CHARTER TOWNSHIP OF GARFIELD PLANNING COMMISSION MEETING

A G E N D A

Charter Township of Garfield Planning Department Report No. 2022-114		
Prepared:	December 7, 2022	Pages: 7
Meeting:	December 14, 2022 Planning Commission	Attachments: <input checked="" type="checkbox"/>
Subject:	SPR 2022-16 Birmley Hills Site Condominium – Findings of Fact	
File No.	SPR 2022-16	Parcel No. 05-026-020-30
Owner:	T&R Investments, Steve Zakrajsek	
Agent:	Boyne Engineering and Design

DRAWING NUMBER
C4.0

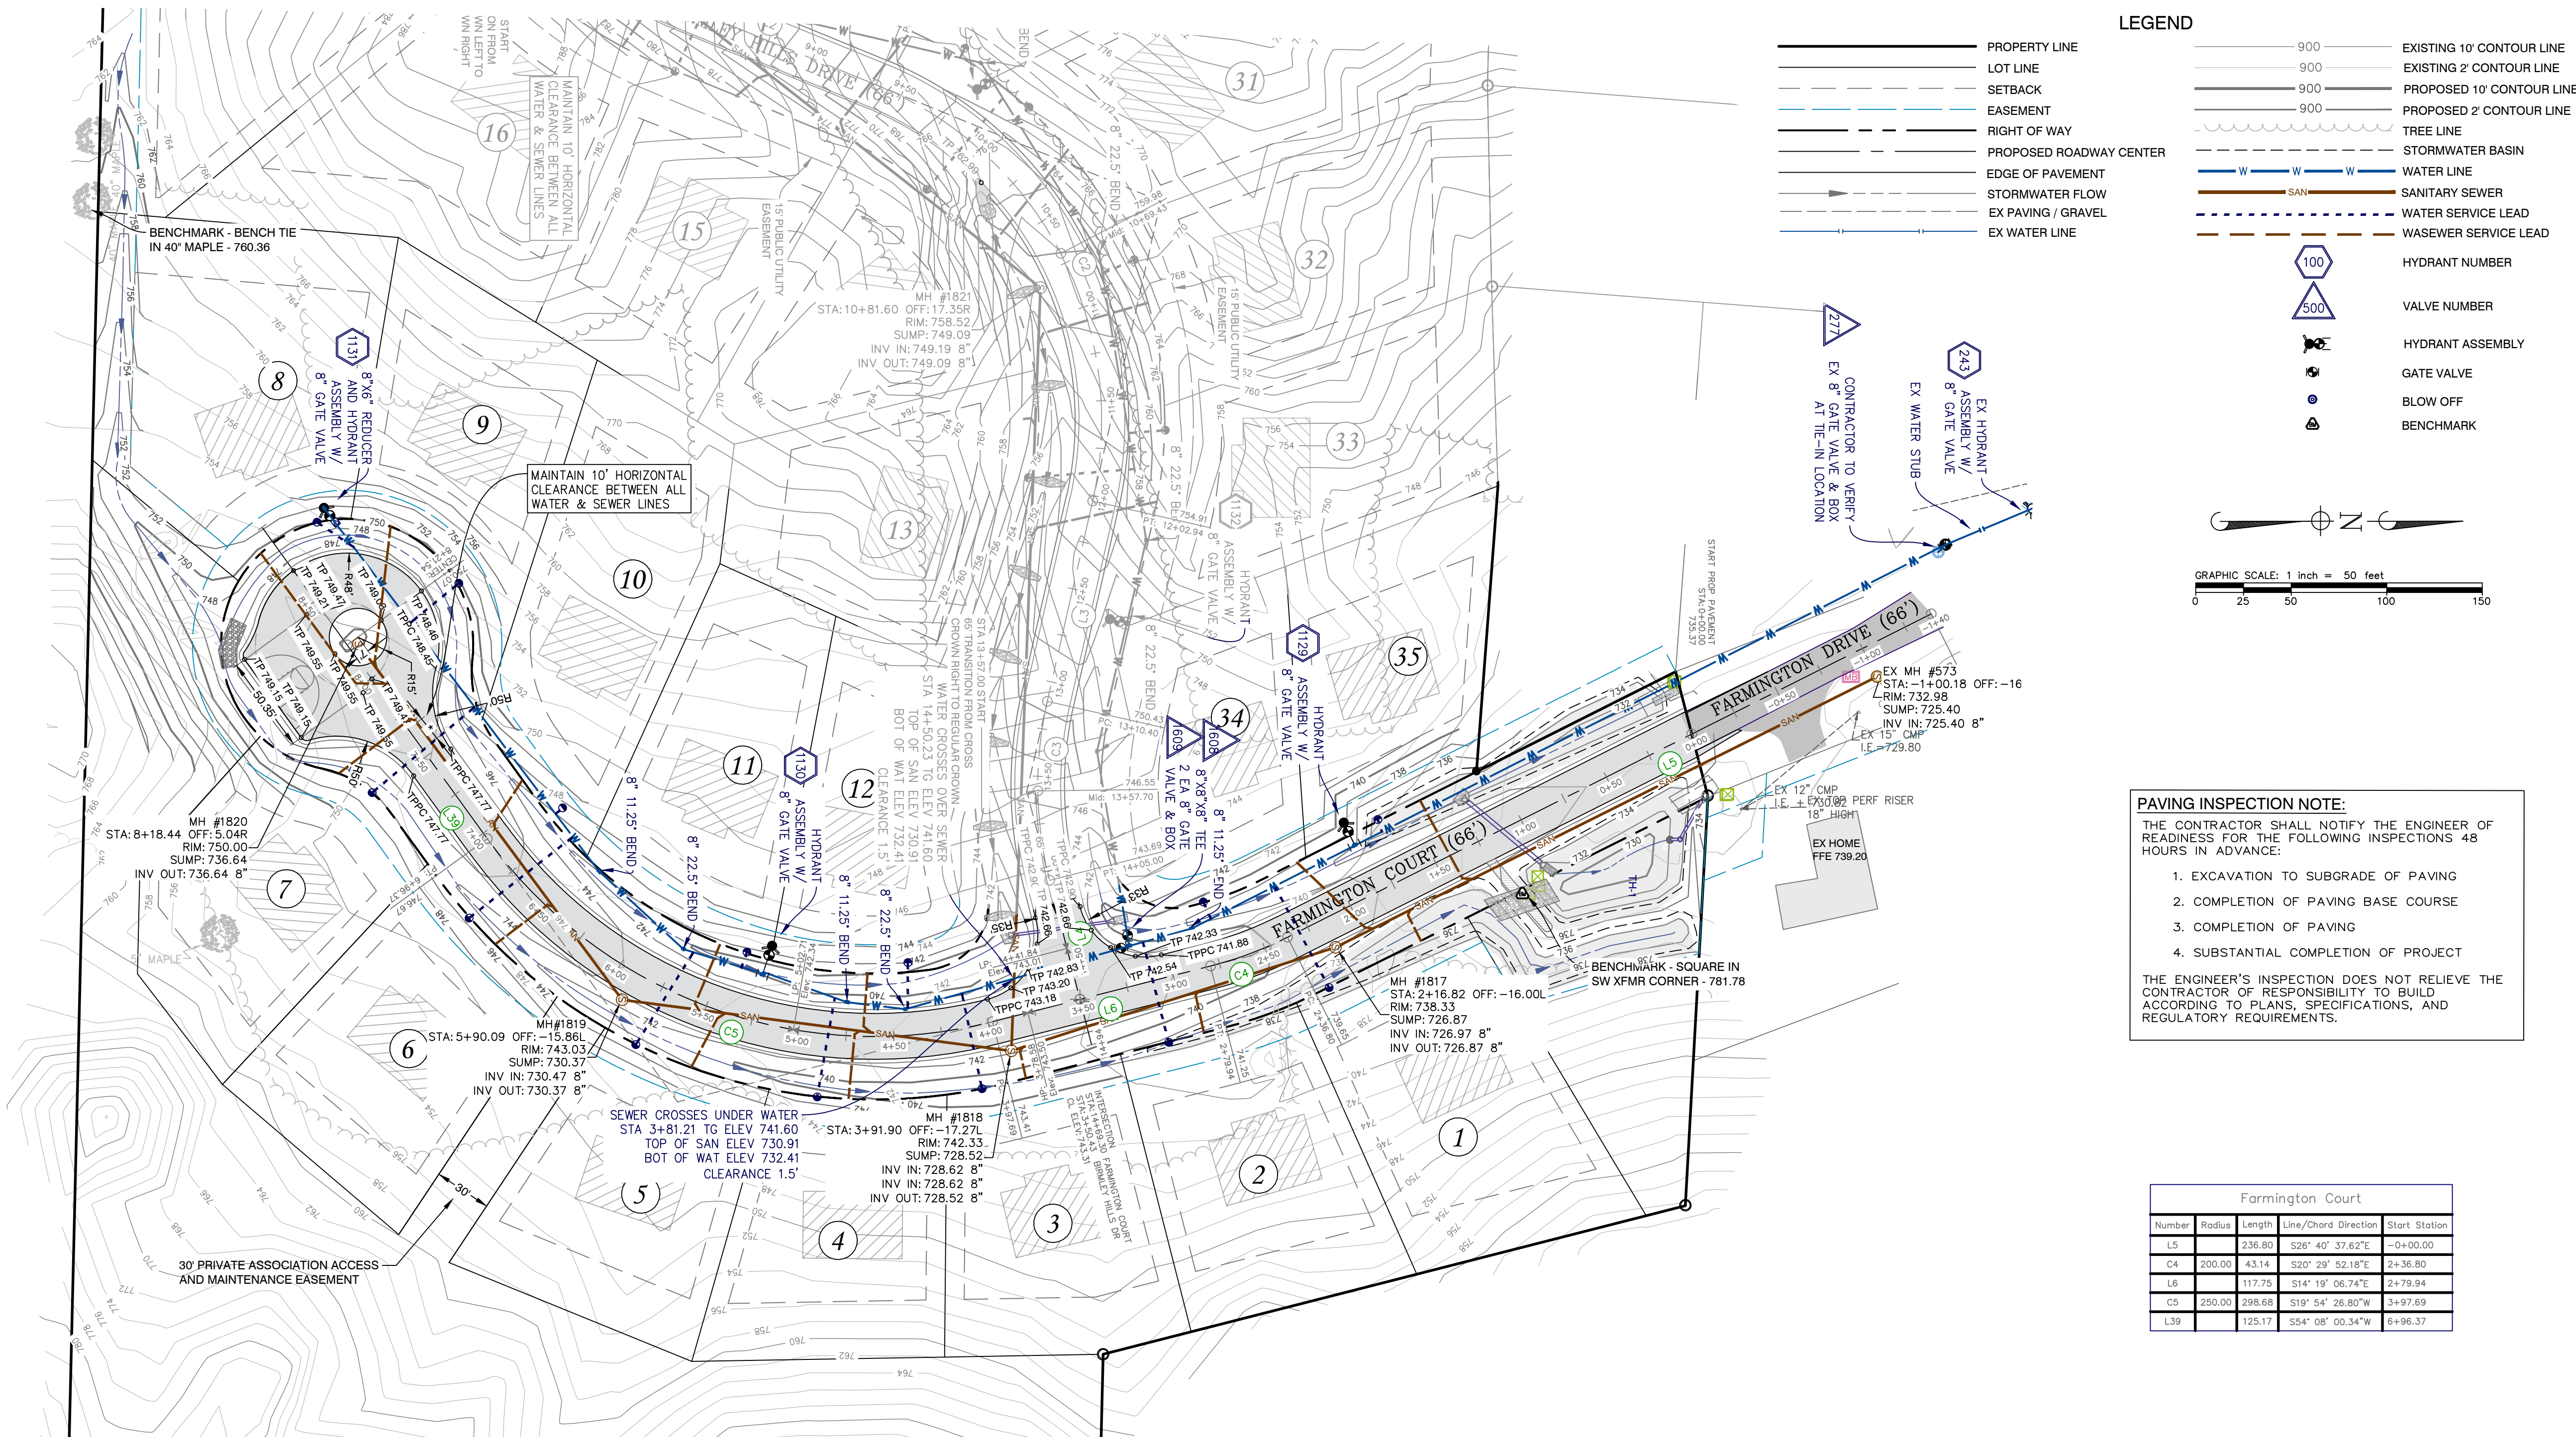
5. Water main stub shall be provided to the abutting western parcel to accommodate a future access.
6. A main line valves shall be installed on Sheet C4.0. Valves are to be installed every 1,000 feet to accommodate isolation.

FARMINGTON COURT
PLAN & PROFILE

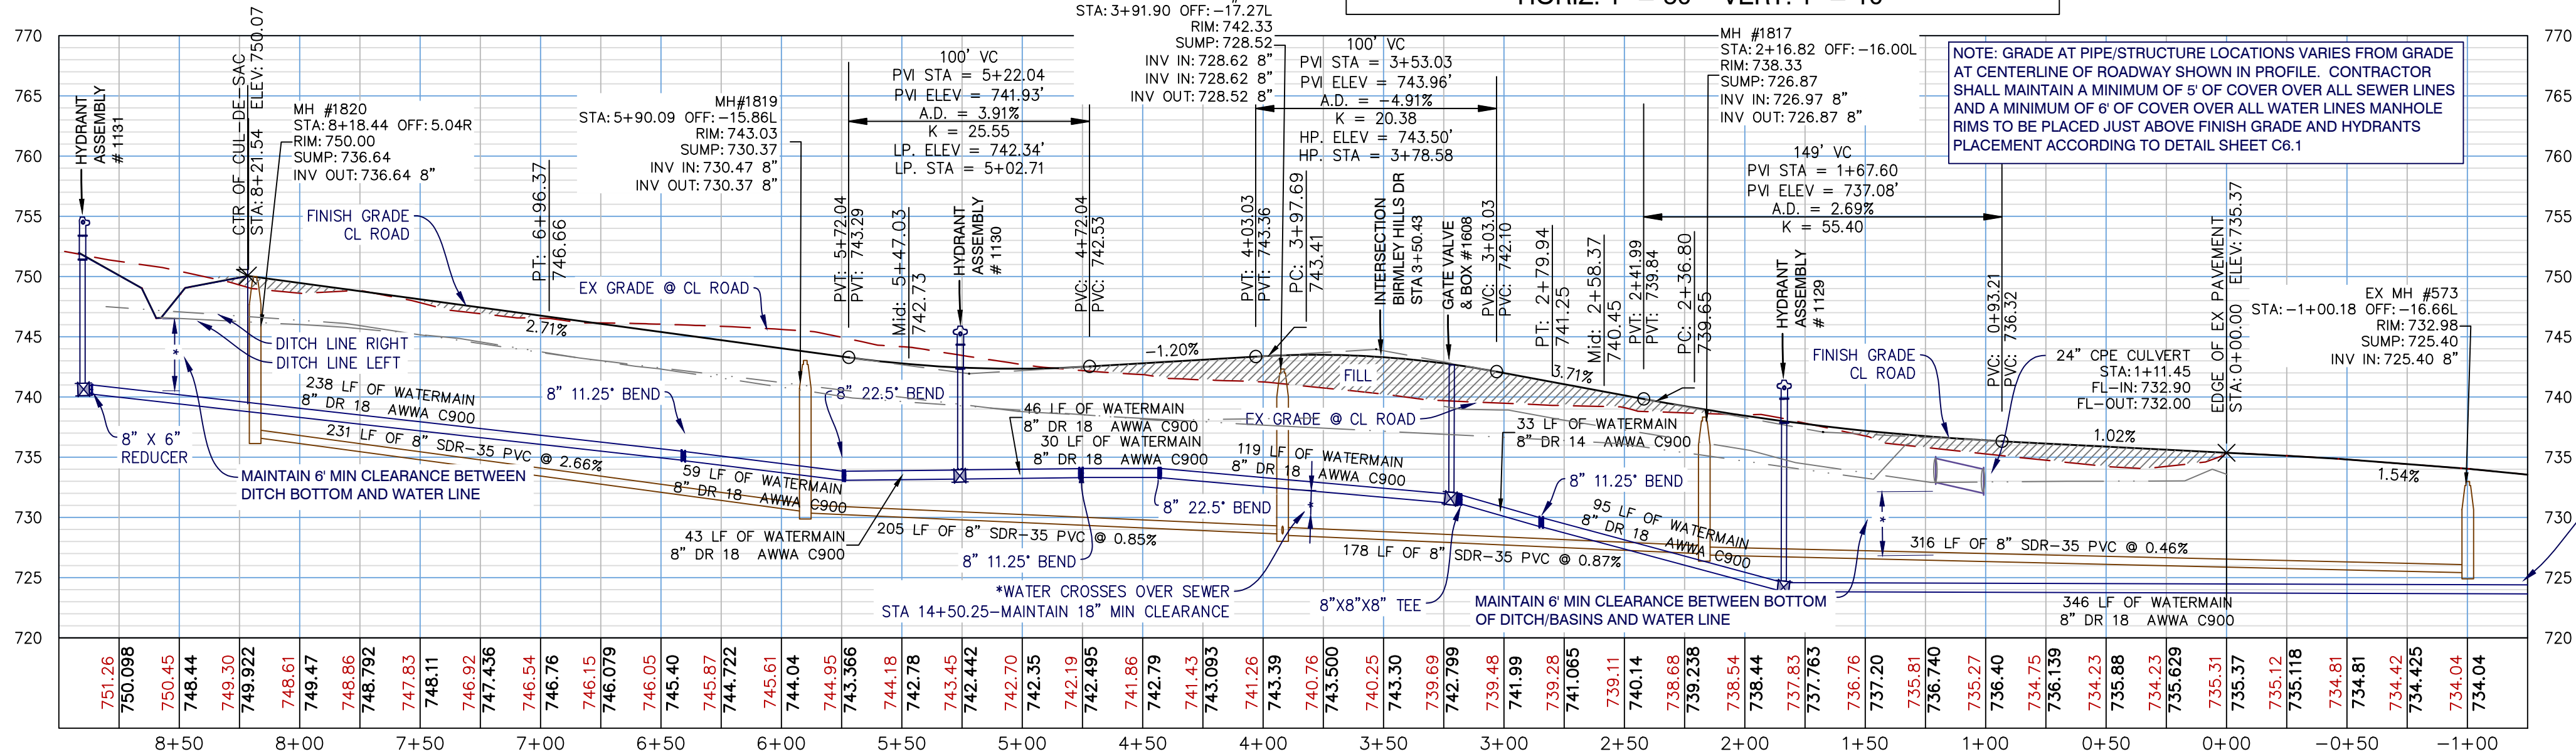
3. Please note that C900 DR 18 is a minimum requirement and DR 14 is proposed.
4. Sheet C4.1 profile sta. 3+25 to 2+75 water main length not called out.
